ADDENDUM NO. 2

FEBRUARY 28, 2024

Staunton City Public Schools, VA
Shelburne Middle School Additions and Renovations
CRA Project No. 3636

3 WALL SECTION
1/2" = 1'-0"

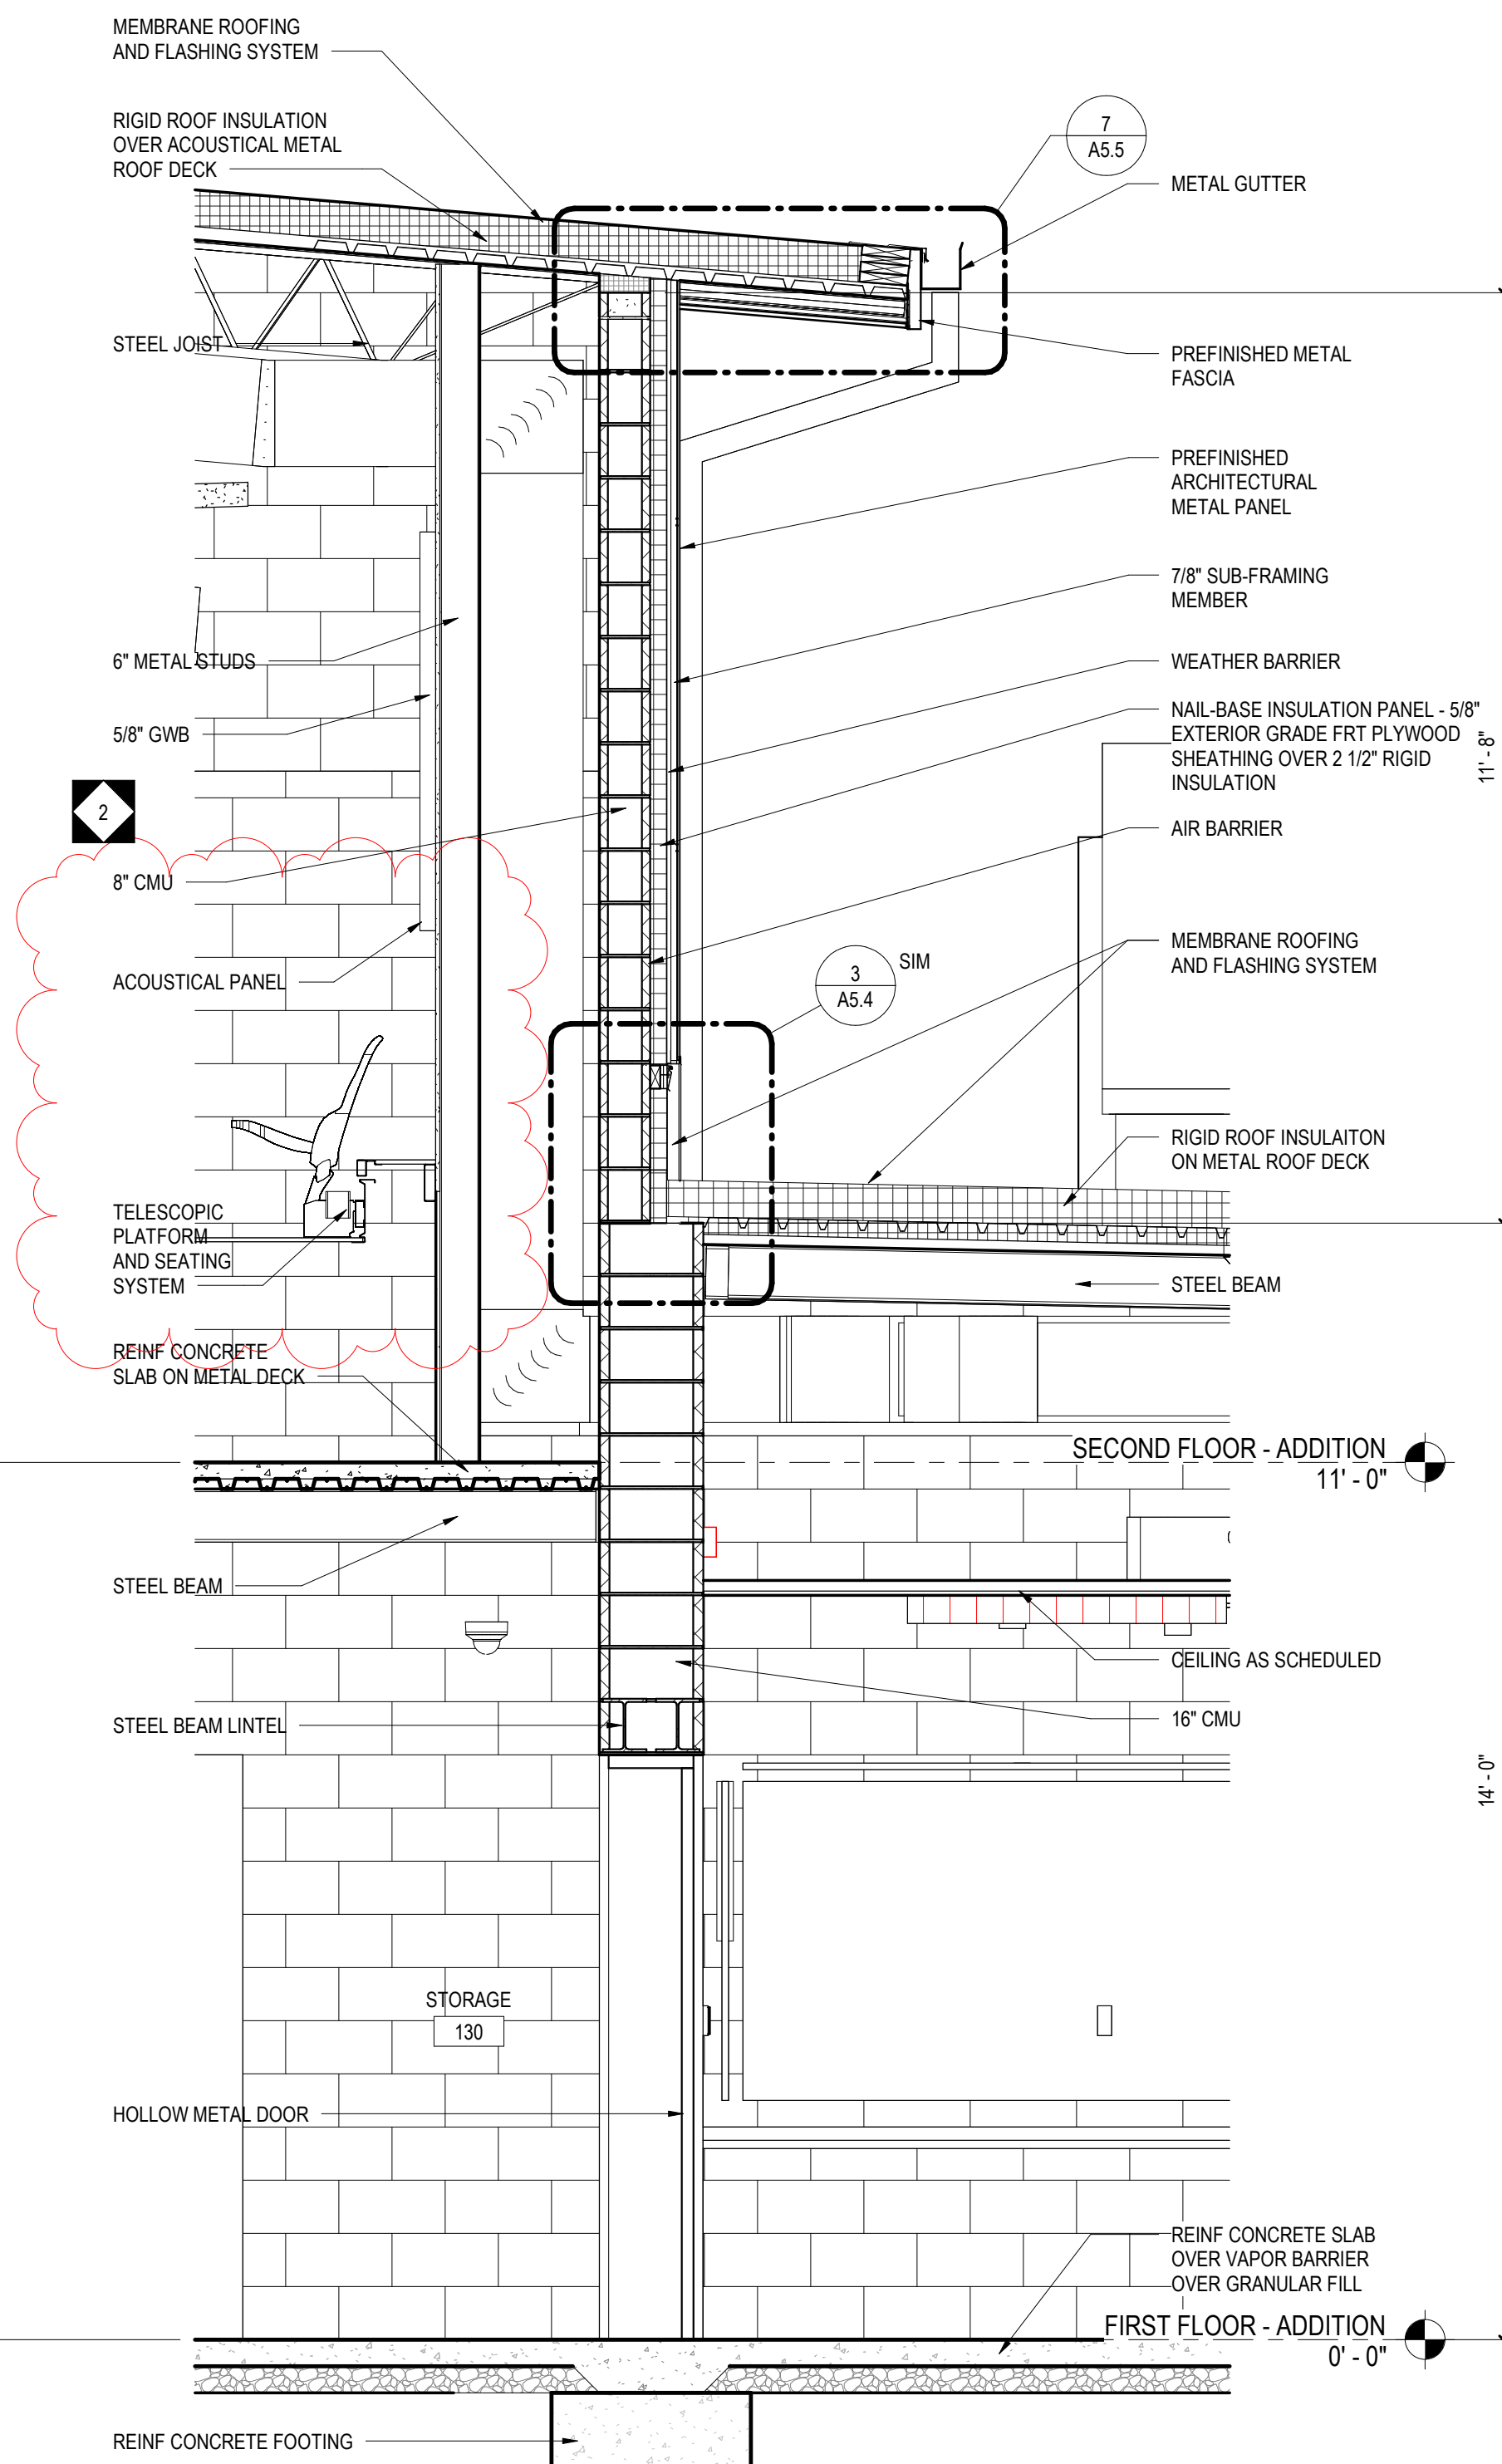
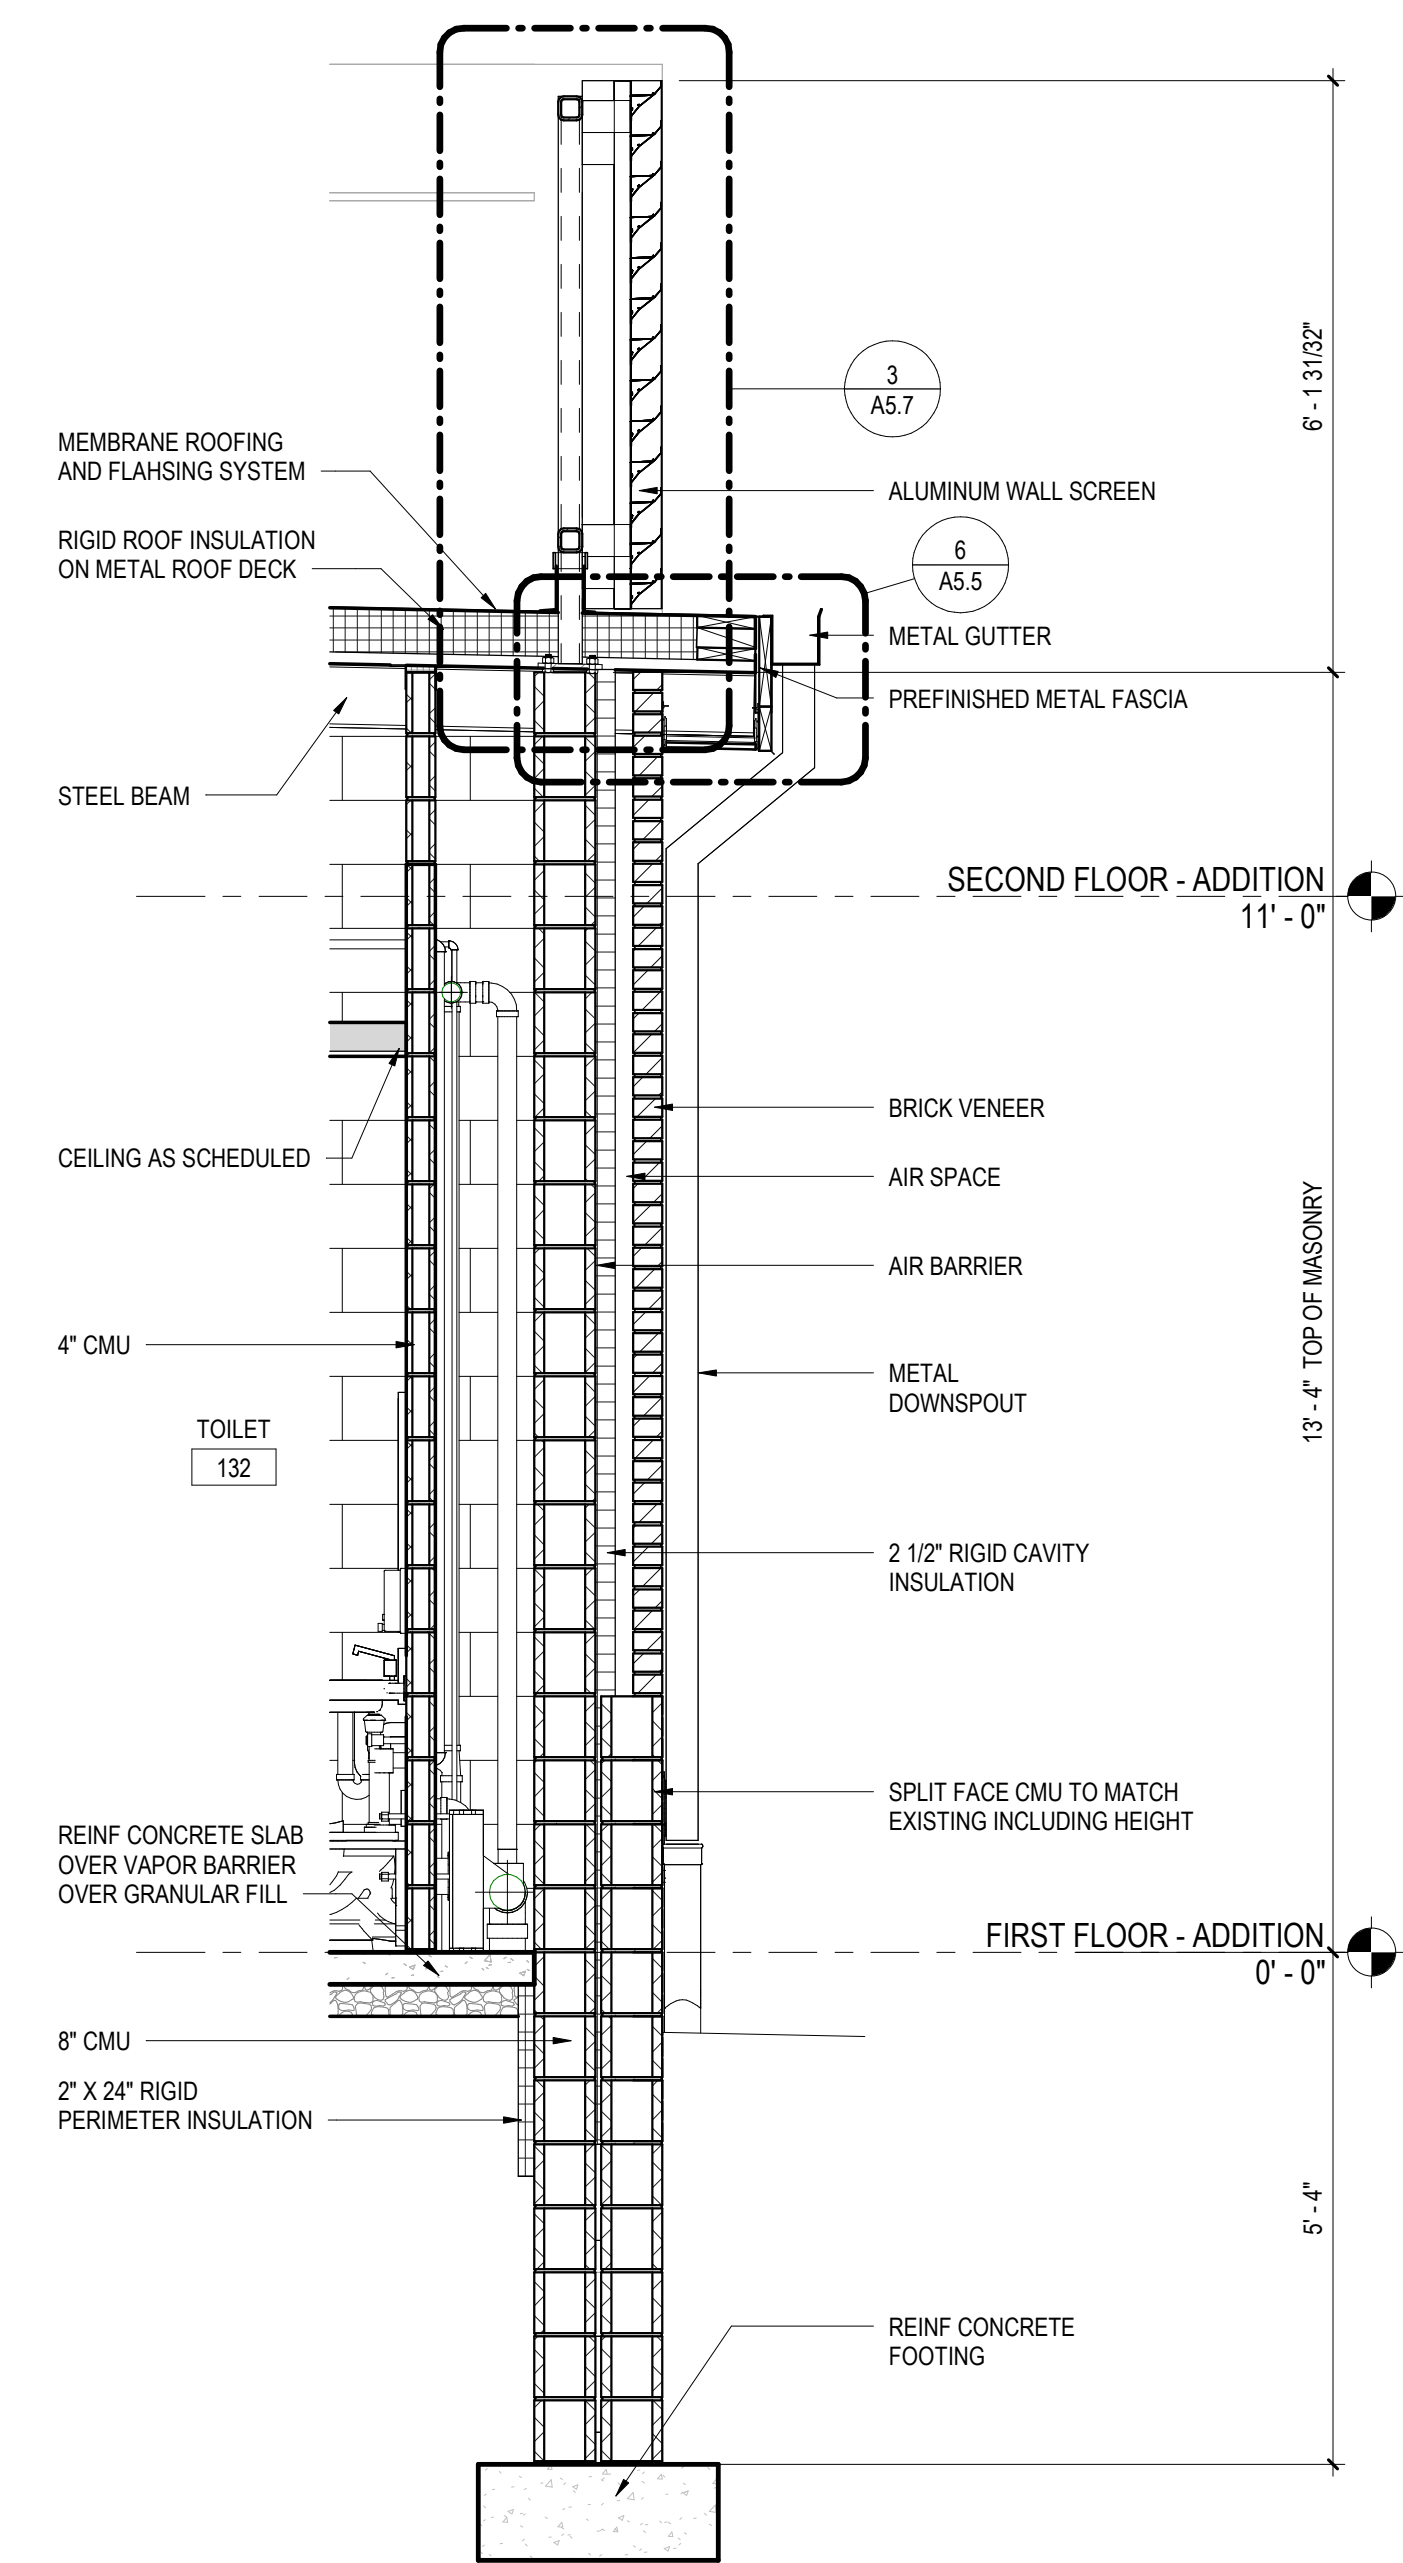
1. **DELETE** this sheet in its entirety and **REPLACE** with the attached sheet.

- a. **REVISED** notes identifying Telescopic Platform and Seating system.
